# UNITED STATES PATENT AND TRADEMARK OFFICE

10/559,619

Kazutaka Matsuzawa

<b>Office Action Summary</b>	<b>Application No.</b> 10/559,619	<b>Applicant(s)</b> MATSUZAWA ET AL.	
	<b>Examiner</b> Craig Price	<b>Art Unit</b> 3753

FIG. 3

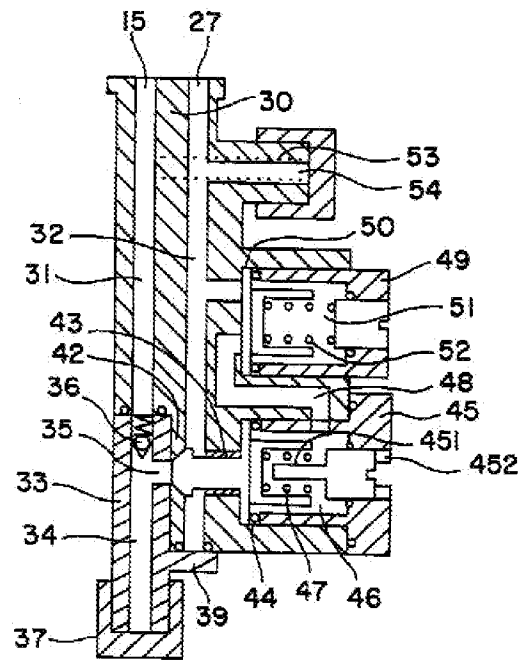
Secondly, regarding claim 1, Taillandier discloses a filling adapter (30) as shown in Figure 3, that includes a first passage (31) that can supply gas to the inner gas chamber by communicating with the air-supply passage for an inner gas chamber, and includes a second passage (32) that can supply gas to the outer gas chamber by communicating with the air-supply passage for an outer gas chamber so as to make a pressure difference between the outer gas chamber and the inner gas chamber, the engaging portion allowing the filling adapter to be mounted so that the air-supply passage for an inner gas chamber communicates with the first passage and the air-supply passage for an outer gas chamber communicates with the second passage.

Regarding claim 5, Taillandier discloses a main body portion (30, see Figure 3) and operating means (the face of 30 near the openings of 15, 27) of Taillandier engages with the valve of Bronson, which is capable of performing the causing of gas in the inner gas chamber and gas in the outer gas chamber to be released to the atmosphere so as not to expand the air pocket, by carrying out a predetermined operation (such as the connection of the device) with respect to the non-return valve member for an inner gas chamber and the non-return valve member for an outer gas chamber of the valve for a safety tire when the main body portion is engaged with the valve for a safety tire.

Regarding claim 8, Taillandier discloses in combination with Bronson and Hawkes that the pressure releasing method according to claim 7, wherein the operating means includes a first protruding portion for operating the non-return valve member for an inner gas chamber, and a second protruding portion for operating the non-return valve member for an outer gas chamber, and the first protruding portion (the protruding portion of 45 is longer than 49, as shown in Figure 3) is longer than the second protruding portion.

FIG. 4

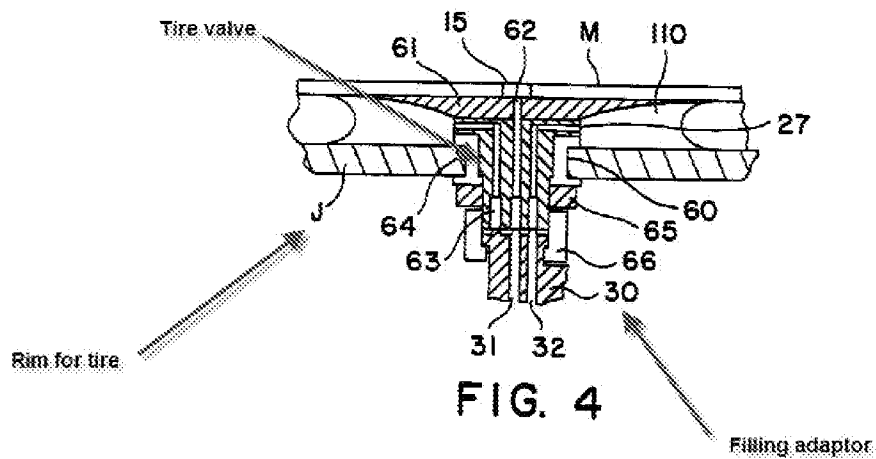
Taillandier discloses that the filling adapter (30, see appended Figure 4 below) with a coupler (66), which engages with a valve for a safety tire wherein the filling adapter is adapted to charge gas from a gas supply source into the outer gas chamber and into the inner gas chamber via the air-supply passage for an outer gas chamber and the air-supply passage for an inner gas chamber (this limitation “for a safety tire...for an inner gas chamber” is considered as an intended use statement bearing no patentable weight), the filling adapter comprising, a main body portion (30) engaging with the valve for a safety tire, a second coupling (33) provided in the main body portion and including a valve core (36) connectable to a pressure source (through 34) to allow gas from the pressure source to be supplied to the tire, an air chamber (31) provided in the main body portion and connected to the second coupling, a first passage (15, 31) provided in the main body portion and causing the air chamber and the air-supply

passage for an inner gas chamber to communicate with each other, a second passage (32) provided in the main body portion and causing the air chamber and the air-supply passage for an outer gas chamber to communicate with each other, and differential pressure setting means (43, piston, Col.4, Lns. 10-15) provided in the second passage and distributing gas from the gas supply source to the first passage and the second passage so as to generate a pressure difference there between, and a first coupling (49,50) connected to the second passage and allowing gas in the outer gas chamber to be released to the atmosphere by carrying out a predetermined operation (such as the operation of removing 49 and 50).
